[Docket No. 98-NM-231-AD; Amendment 39-11538; AD 2000-02-20]

Airworthiness Directives; Boeing Model 767 Series Airplanes Equipped With General Electric Model CF6-80C2 Series Engines

ACTION: Final rule.

Electro-Mechanical Brake and CDU Cone Brake Torque Check
Figure 1

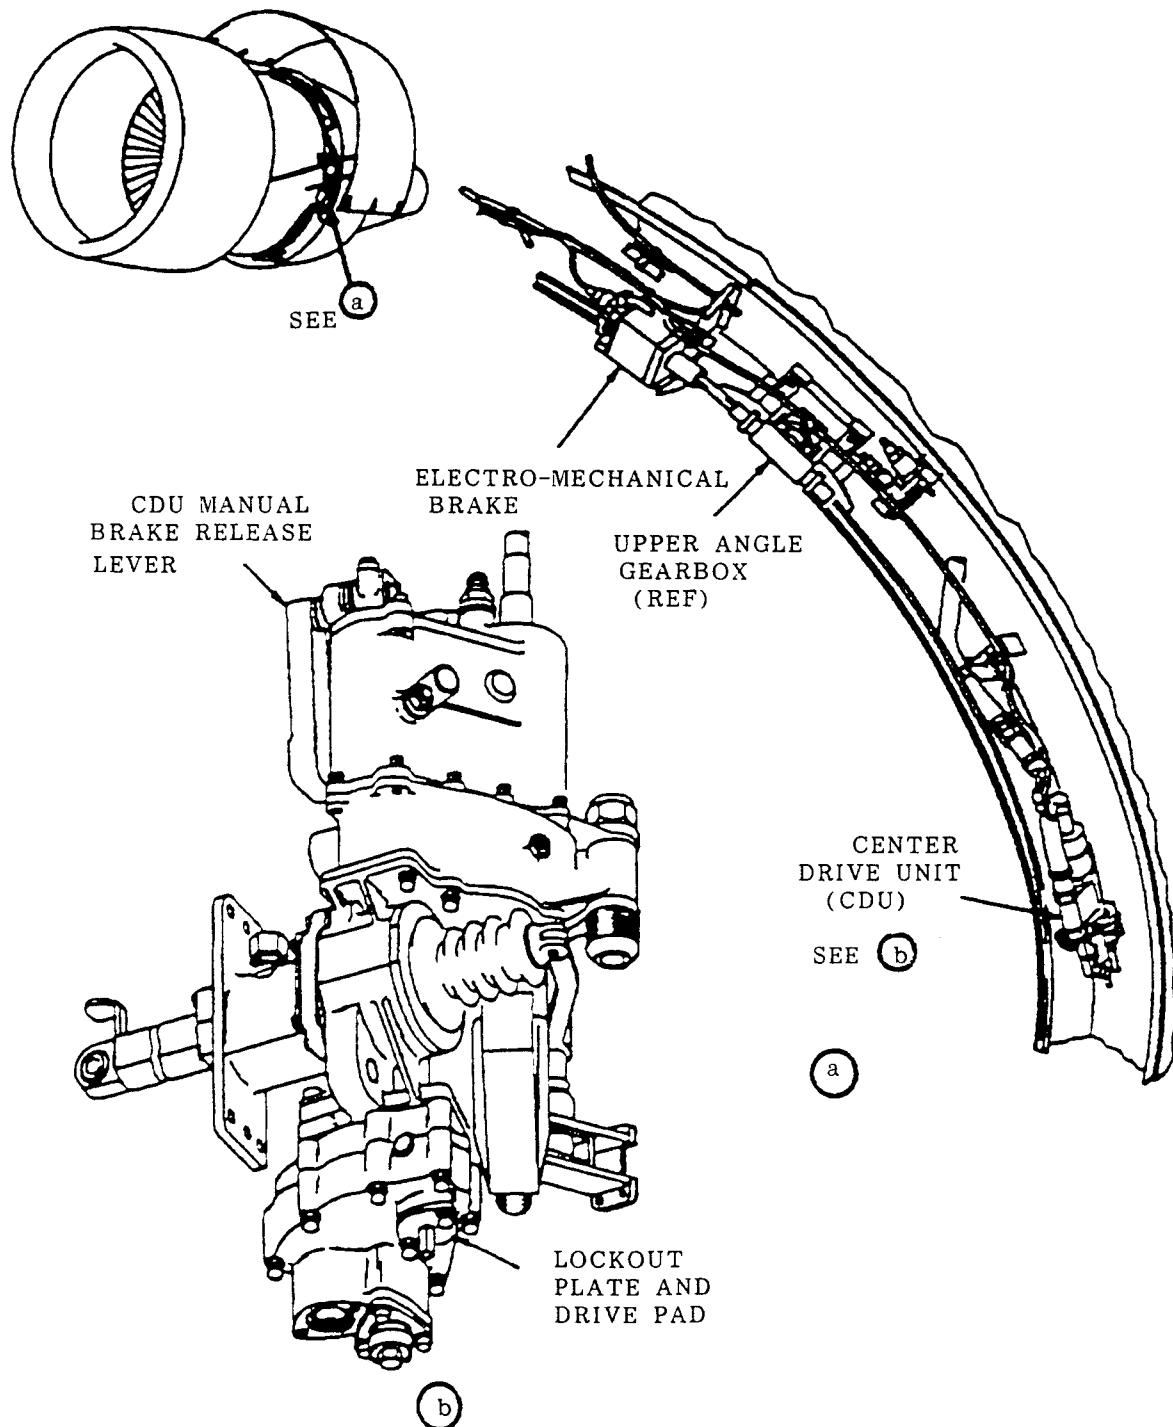
2. Electro-Mechanical Brake and CDU Cone Brake Torque Check (Fig. 1)

(e) Apply 90 pound-inches of torque to the system.

(1) The electro-mechanical brake system is working correctly if the torque is reached before you turn the wrench 450 degrees ($1\frac{1}{4}$ turns).

(2) If the flexshaft turns more than 450 degrees before you reach the specified torque, you must replace the long flexshaft between the CDU and the upper angle gearbox.

(3) If you do not get 90 pound-inches of torque, you must replace the electro-mechanical brake.

CAUTION: DO NOT USE MORE THAN 100 POUND-INCHES OF TORQUE WHEN YOU DO THIS CHECK. EXCESSIVE TORQUE WILL DAMAGE THE CDU.

(6) Turn the torque wrench to try to manually extend the translating cowl until you get at least 15-pound inches.

Note: The cone brake prevents movement in the extend direction only. If you try to measure the holding torque in the retract direction, you will get a false reading.

(a) If the torque is less than 15-pound-inches, you must replace the CDU.
